<b>Project:</b>	2023-RFT-058 Lift Station 1 & Lower Iqaluit PT.A2 to LS1 Project		
<b>Addendum No.</b>	4	<b>No. of Pages:</b>	16
<b>Date:</b>	August 14, 2023	<b>Doc. No:</b>	P7201-810372863-118(1.0)

The following change(s) in the Request for Quotation Documents are effective immediately.  
This Addendum forms part of the Contract Documents.

#### DRAWING REVISIONS

Revision F Drawing No. S-103

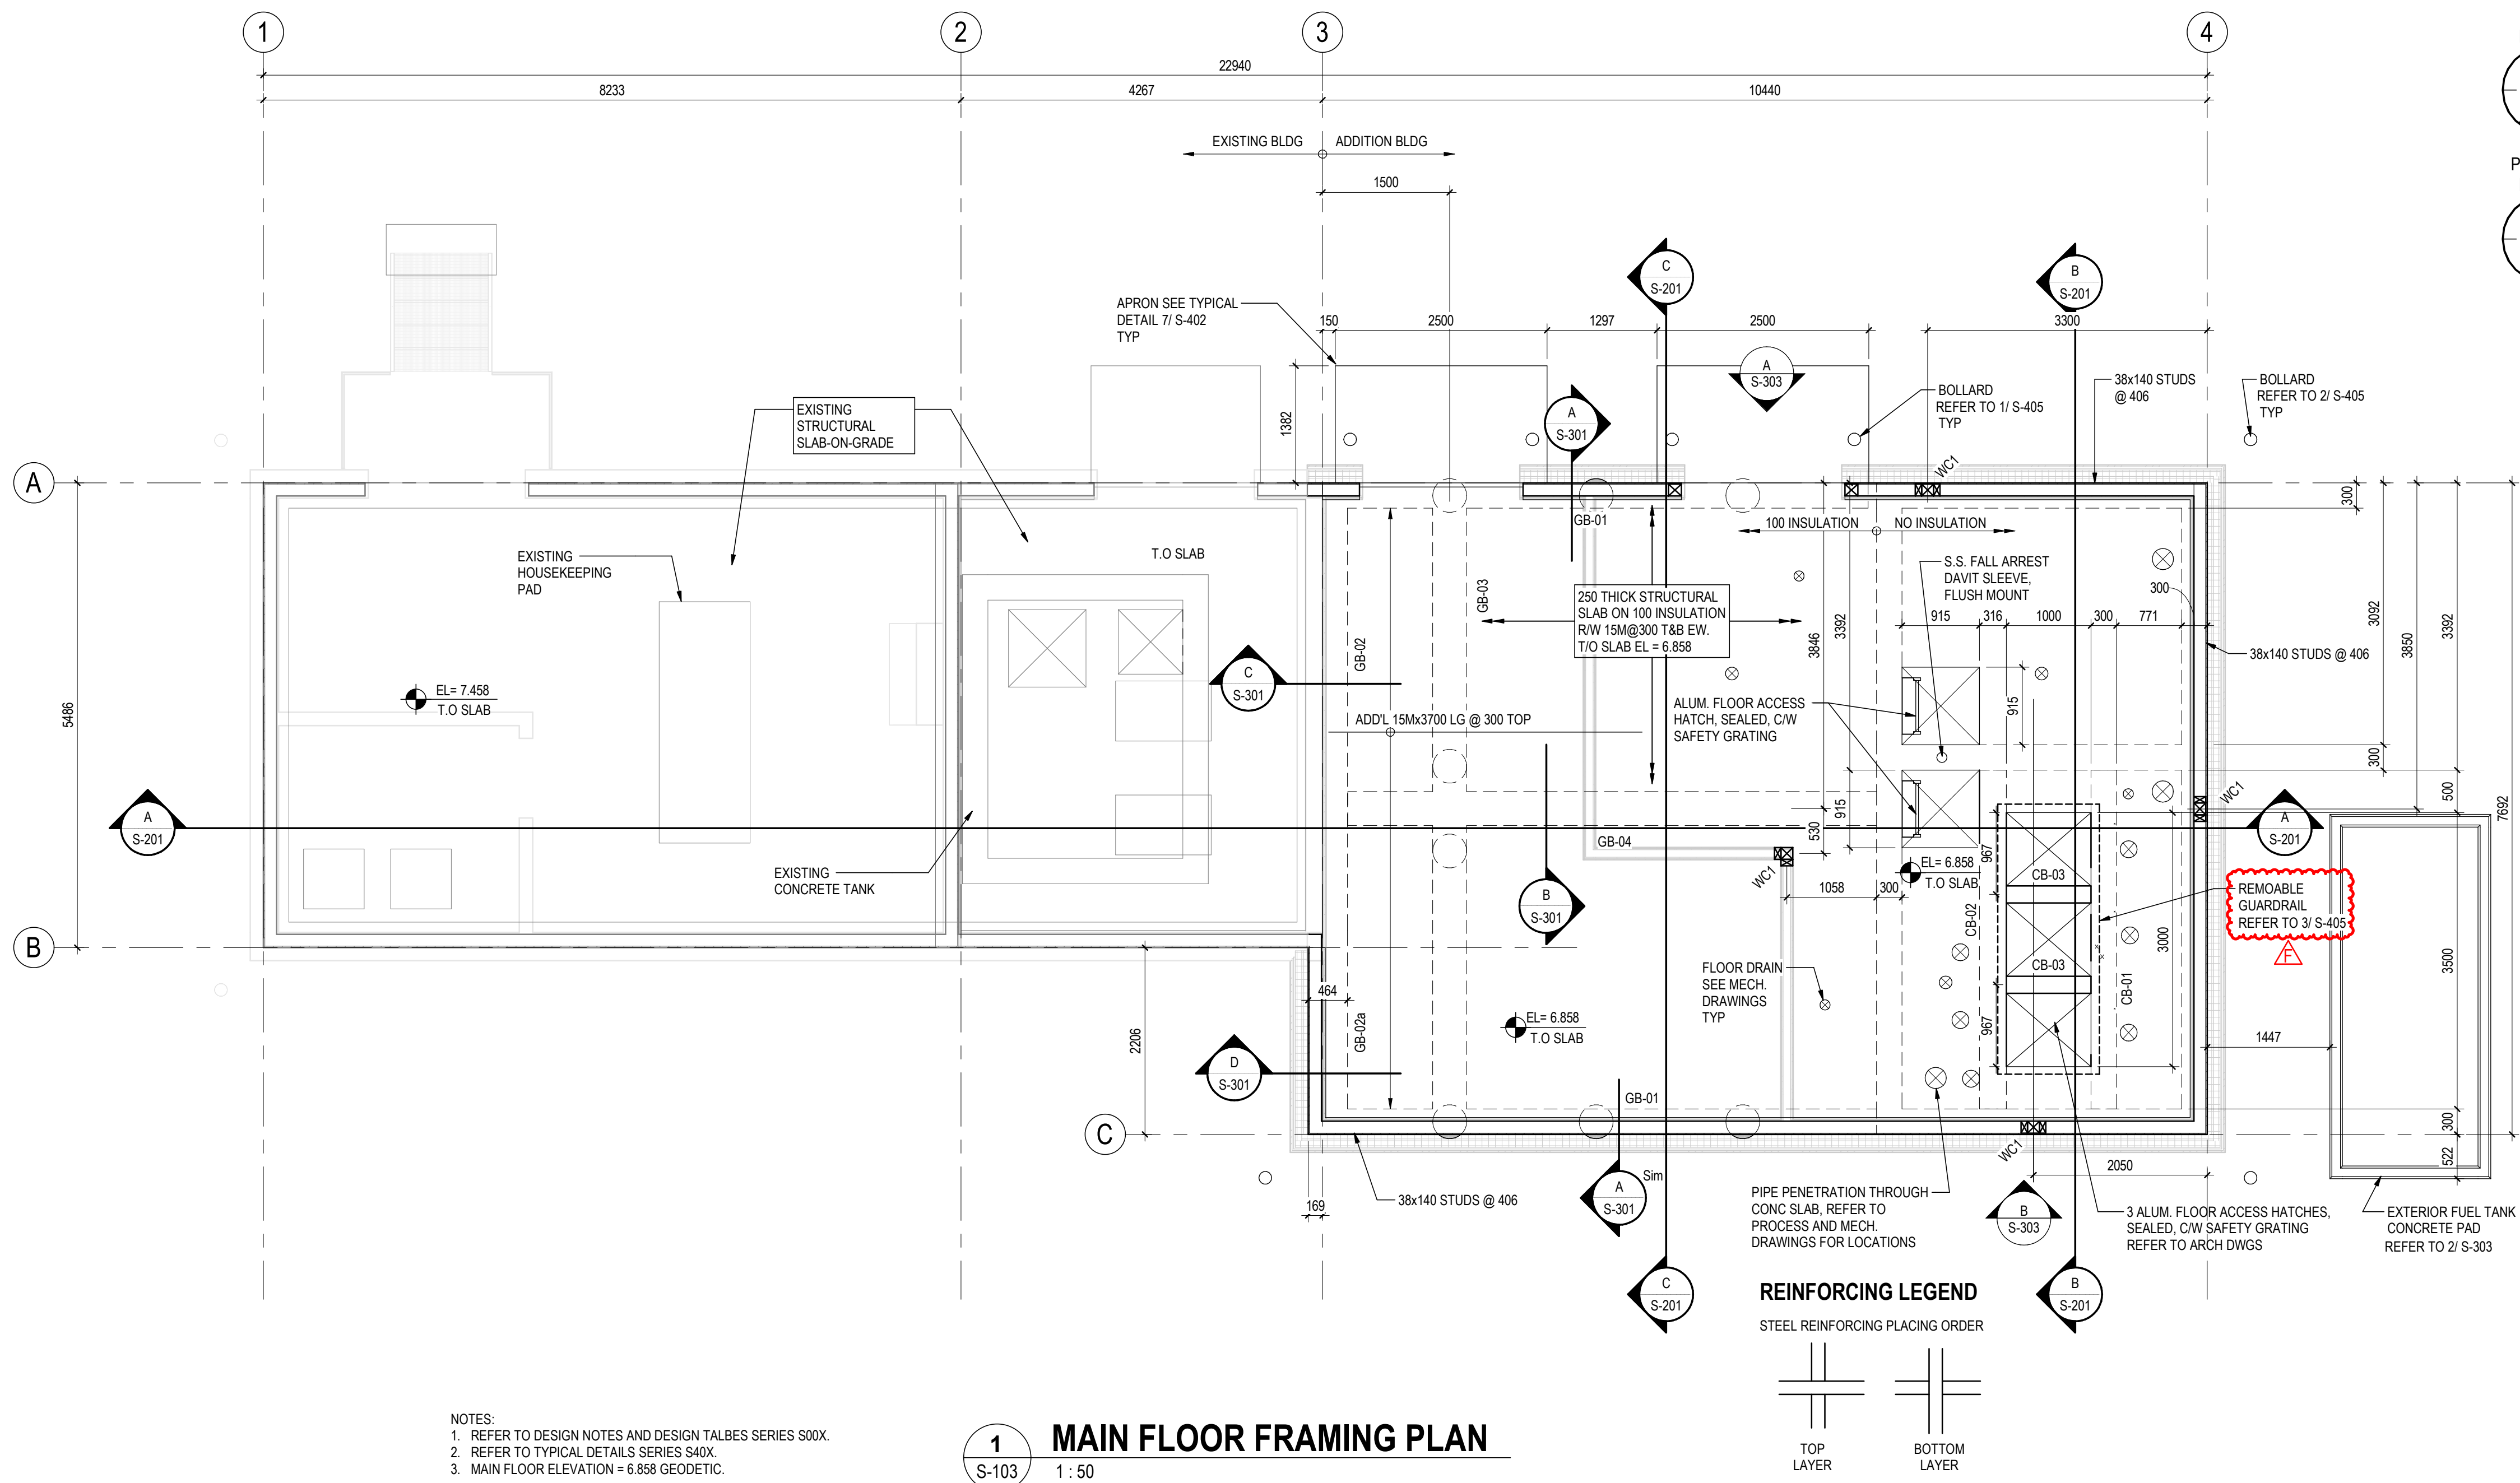
**Q8.** The structural plan indicates 18" TJI joists and rim board, the joist manufacturer recommends changing the details at bearing from continuous rim board to TJI blocking panels. Would this be acceptable?

**Q9.** As this is a TJI roof, the joist manufacturer would recommend adding blocking panels to the design. Would this be acceptable?

**A8:** This is acceptable.

**A9:** This is acceptable.

STRUCTURAL  
LIFT STATION NO. 1  
SECTIONS AND DETAILS SHEET 1 OF 3

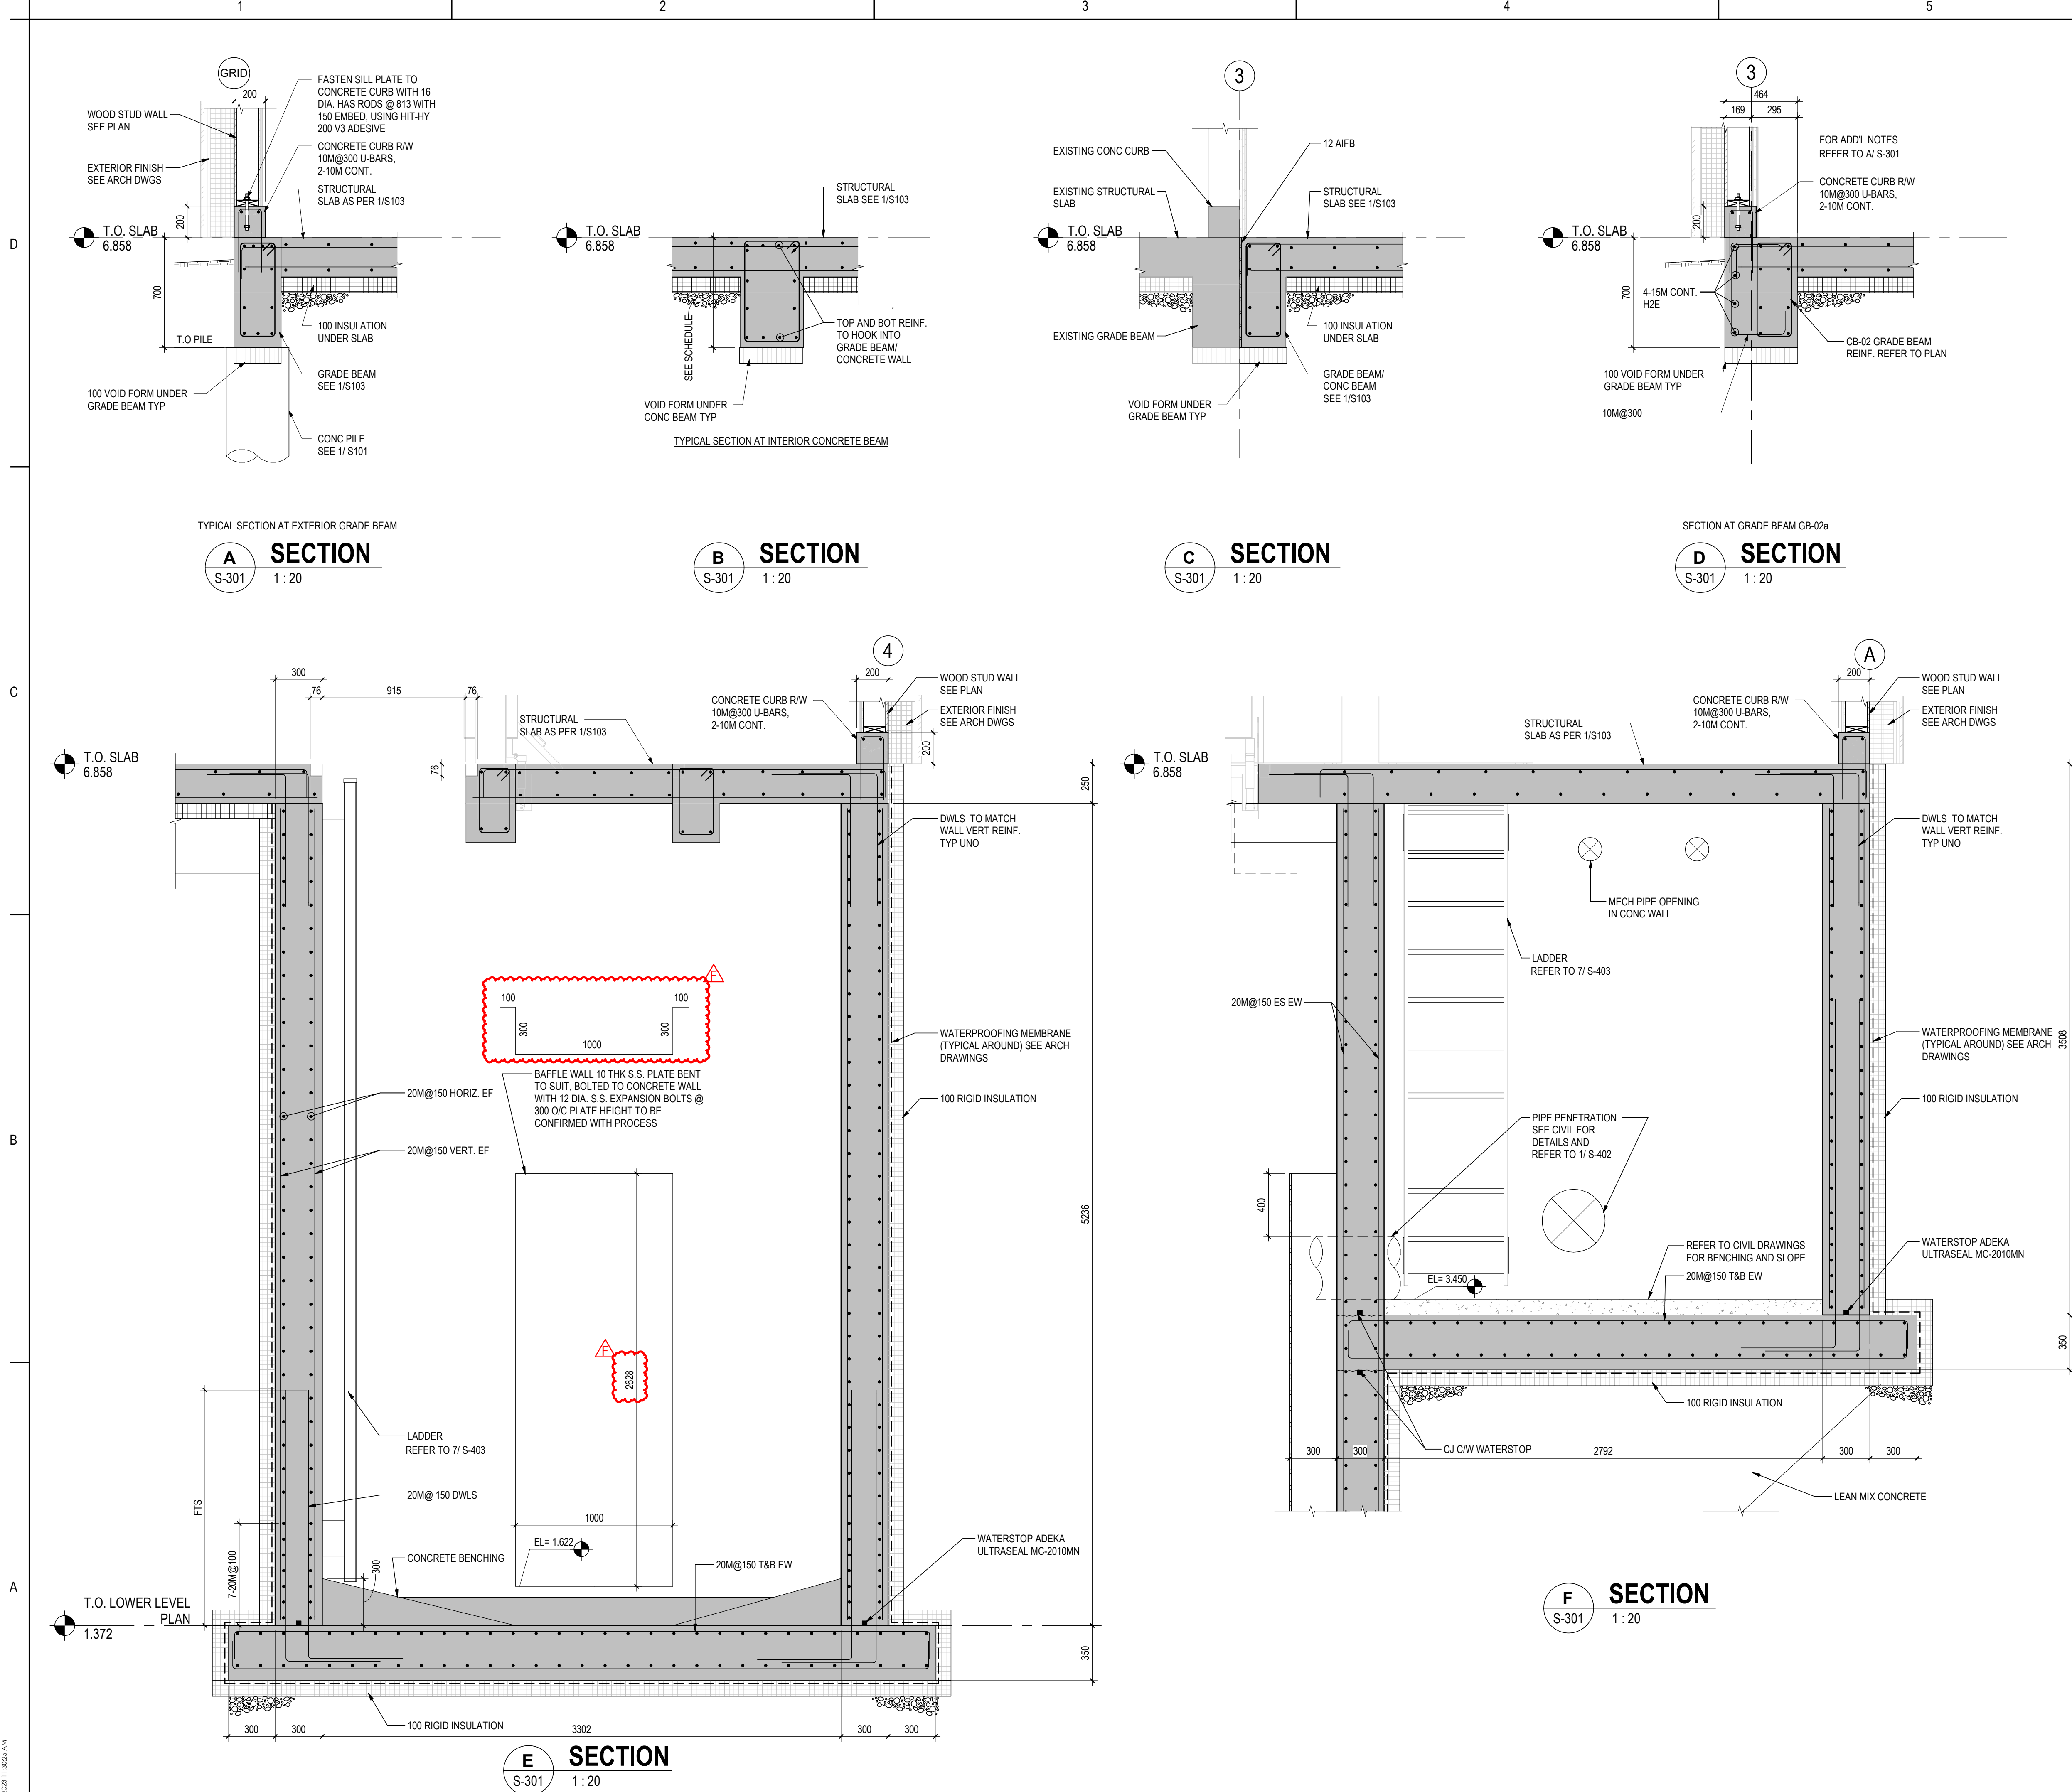
- Q5.** Please provide dimensions and detail on the baffle wall including bent plate details.
- A5:** Refer to drawings provided with this addendum.
- Q6.** On S-002 it is indicated that we should refer to plans for analysis of snowdrift and wind uplift but there are no diagrams for snowdrift or wind uplift. Please provide the diagrams.

- A6:** There is no snow drift. For wind uplift, refer to drawings provided with this addendum.
- Q7.** Can you provided the anticipated peak flow rates from existing sewers entering LS1?
